Service Provider Letter

Jurisdiction:	<u>City of Sherwood</u>	Review Type:	<u>Tier 2 Analysis</u>
Site Address	<u>15665 SW Willamette St</u>	SPL Issue Date:	<u>September 23, 2025</u>
/ Location:	<u>Sherwood, OR 97140</u>	SPL Expiration Date:	<u>September 23, 2027</u>

Sherwood Old Town Apartments

**SENSITIVE
AREAS SITE
PLAN**

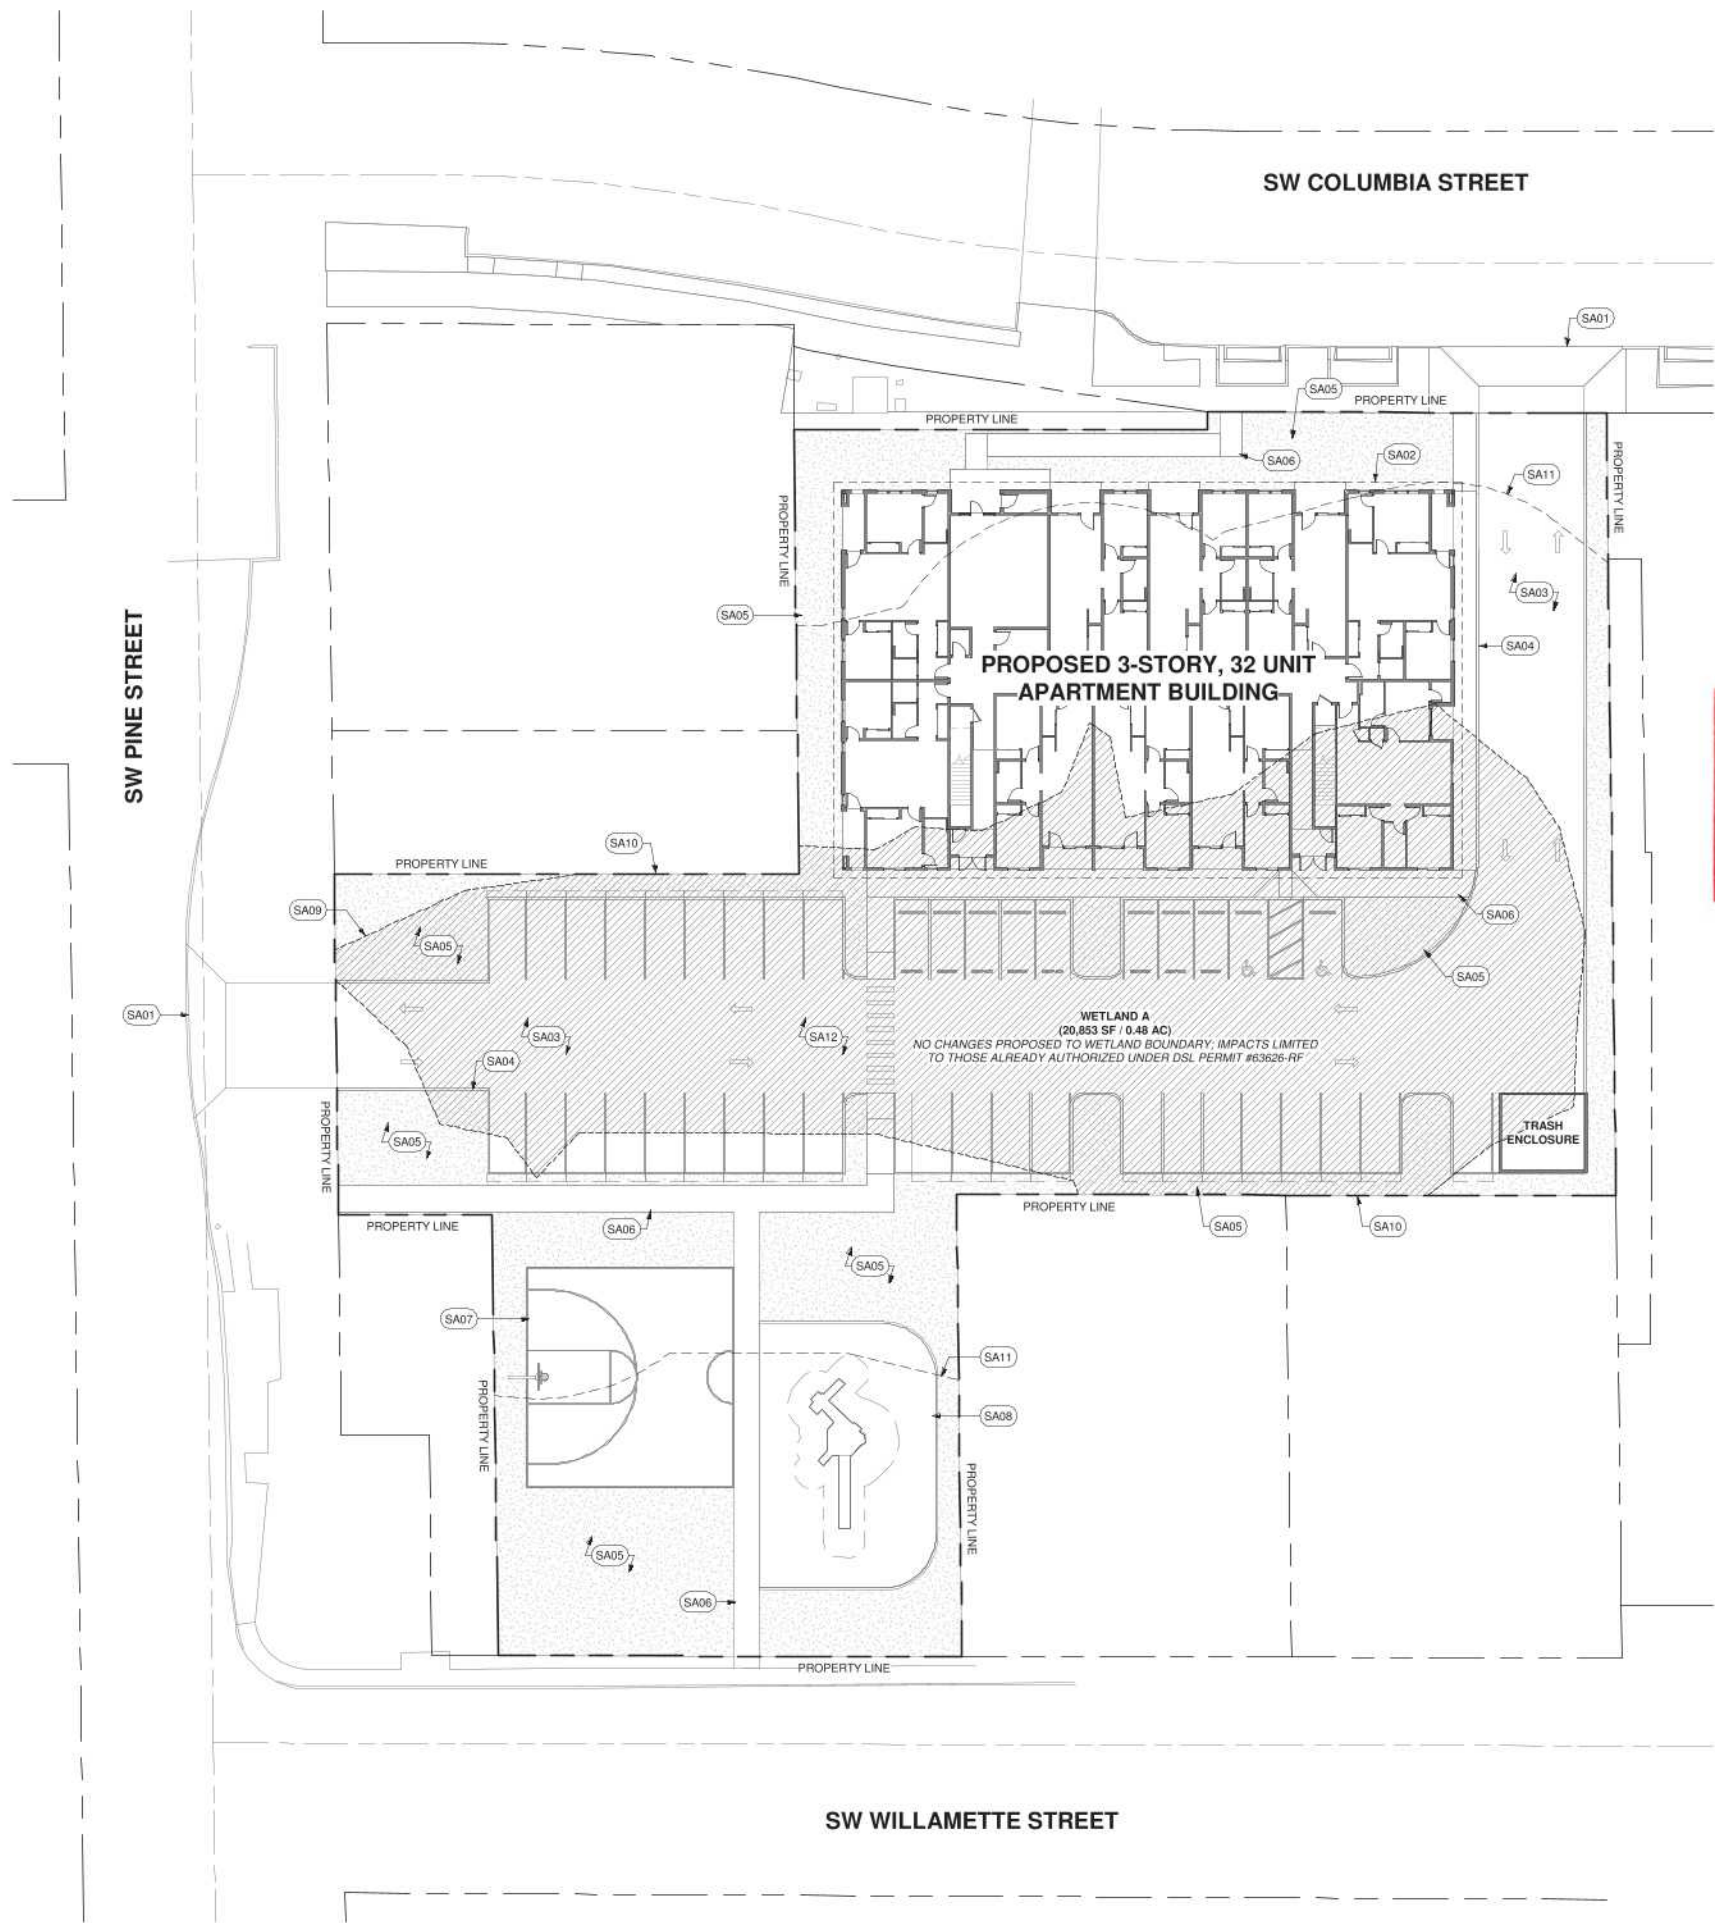
- 4. The water quality swale and detention pond shall be planted with Clean Water Services approved native species, and designed to blend into the natural surroundings.**

- 5. Should final development plans differ significantly from those submitted for review by Clean Water Services, the applicant shall provide updated drawings, and if necessary, obtain a revised Service Provider Letter.**

This Service Provider Letter is not valid unless CWS-approved site plan is attached.
